Commission of Architectural Review

9. COA-176753-2025	Final Review	Meeting Date: 12/16/2025
Applicant/Petitioner	Christopher Raynore	
Project Description	Construct a two-story single-family residence on a vacant lot	
Project Location		
Address: 520 Brook Road		
Historic District: Jackson Ward		
<p>High-Level Details:</p> <p>The applicant proposes new construction of a small, two-story single-family residence with basement and rooftop terrace at 520 Brook Road, located within the Jackson Ward Old and Historic District. The lot is triangular and limited in buildable area.</p> <p>The proposed infill building uses cementitious siding, vertically aligned windows, and a simple form with a modern interpretation.</p> <p>The project will require a Special Use Permit.</p>		
Staff Recommendation	Approval, with Conditions	
Staff Contact	Yara Iwaz, Yara.Iwaz@RVA.gov, (804)646-6031	
Previous Reviews	<p>At the June 24, 2025 conceptual review the Commission made the following recommendations:</p> <ul style="list-style-type: none"> • Recognize site constraints and support sensitive massing and composition. • Encourage the use of brick and support a non-standard running bond and color as appropriat

Figure 3: previous elevation drawings

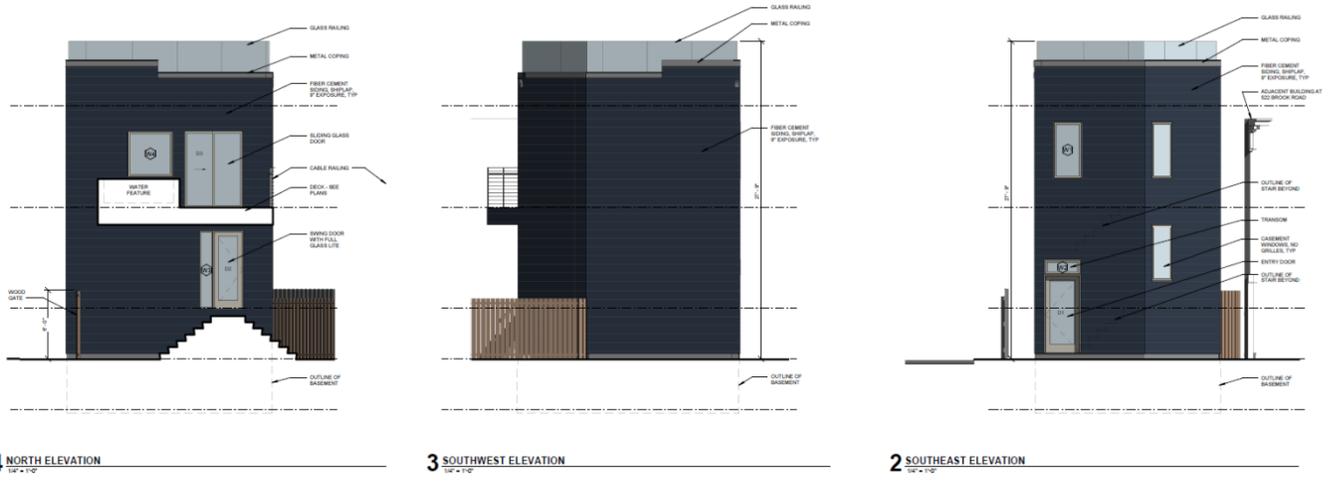
<p>These changes create a well-defined base, a better integrated elevation and a top that respects the heights of the surrounding structures and provides a clear visual termination at the top of the façade.</p> <p>The main entrance to the building presents a better interaction with the street that is consistent with the pedestrian-focused orientation typical of Jackson Ward. The recessed form is an appropriate response to the challenges posed by the lot size and setback constraints. Elevating the entry door identifies it as a more formal principal access to the building, which is consistent with the previous recommendations outlined in the conceptual review.</p> <p><u>Staff recommends approving the design of the primary elevation.</u></p>
Standards for New Construction: Materials & Colors, page 47	<i>2. Materials used in new residential construction should be visually compatible with original materials used throughout the district.</i>	<p>The exterior materials have been revised from a fiber cement siding to a light-brown brick in a running-bond pattern, responding to the Commission’s suggestion for a natural material, and in-line with the applicant’s goal of using natural and sustainable materials.</p> <p><u>Staff recommends approving the brick materials as submitted.</u></p>

<p>The previous north elevation featured a cantilevered balcony that potentially encroached on the adjacent lot. This elevation has been revised to instead have a metal spiral staircase that provides access to the vegetation roof.</p> <p><u>Staff recommends confirming with zoning whether the external spiral staircase is permissible.</u></p>
Standards For New Construction, p.47	<i>5. Rooftop mechanical equipment should be located as discretely as possible to limit visibility. In addition, appropriate screening should be provided to conceal equipment from view. When rooftop railings are required for seating areas or for safe access to mechanical equipment, the railings should be as unobtrusive as possible, in order to minimize their appearance and visual impact on the surrounding district.</i>	<p>The earlier design proposed a glass guardrail at the rooftop level, which raised questions regarding visibility, material reflectivity, and compatibility with the surrounding historic context. The applicant has since revised the design to incorporate a solid brick parapet with a simple metal coping. This modification provides a more coherent base-middle-top expression, reinforces the building’s masonry character, and improves the building’s contextual relationship to the block and to Abner Clay Park, where the roofline will be prominently visible.</p> <p>Mechanical system placement has not yet been illustrated on the updated drawings.</p> <p><u>Staff recommends approval of the revised parapet design. Final mechanical equipment location and screening method to be submitted for staff review and approval.</u></p>

Figure 4: current elevation drawings

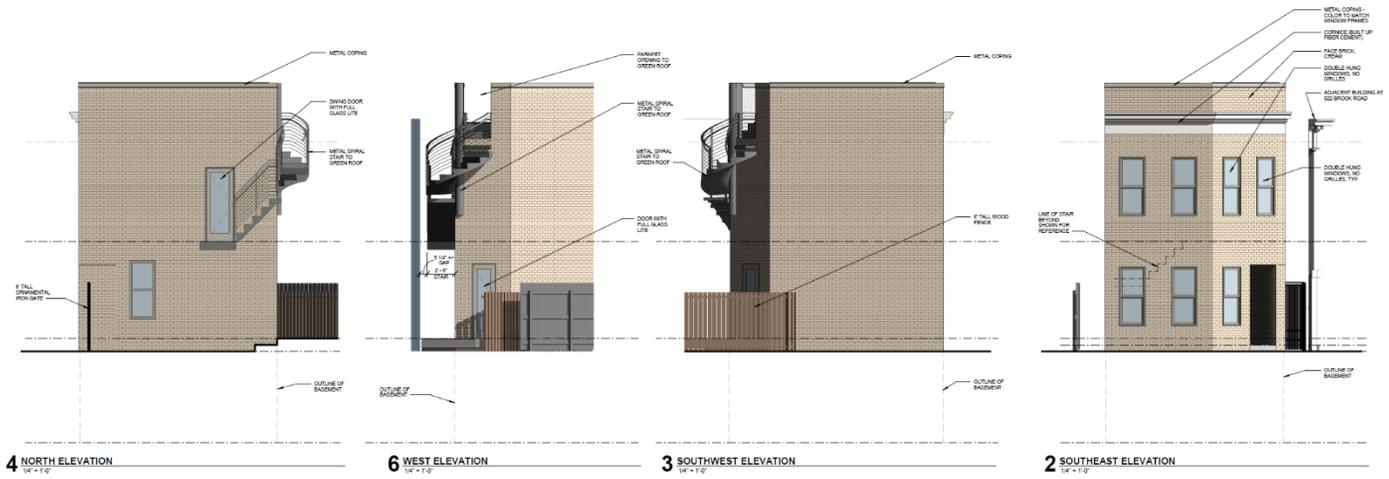
Standards For New Construction: Doors and Windows, p.56	<i>2. The size, proportion and spacing patterns of door and window openings on free-standing new construction should be compatible with patterns established in the district</i>	<p>The window configuration has been significantly improved from the earlier concept. The revised design incorporates full-size, vertically windows that increase overall transparency and better reflect the typical void-to-solid ratios found on contributing buildings in the district. The use of simple, punched openings helps distinguish the building as contemporary construction while maintaining compatibility with historic fenestration patterns along Brook Road and in Jackson Ward. The fenestration pattern strengthens the</p>

façade composition and aligns with Commission guidance from the conceptual review. <u>Staff recommends approval of the window approach as shown. Final window specifications to be submitted for staff review and approval.</u>
--	--	--
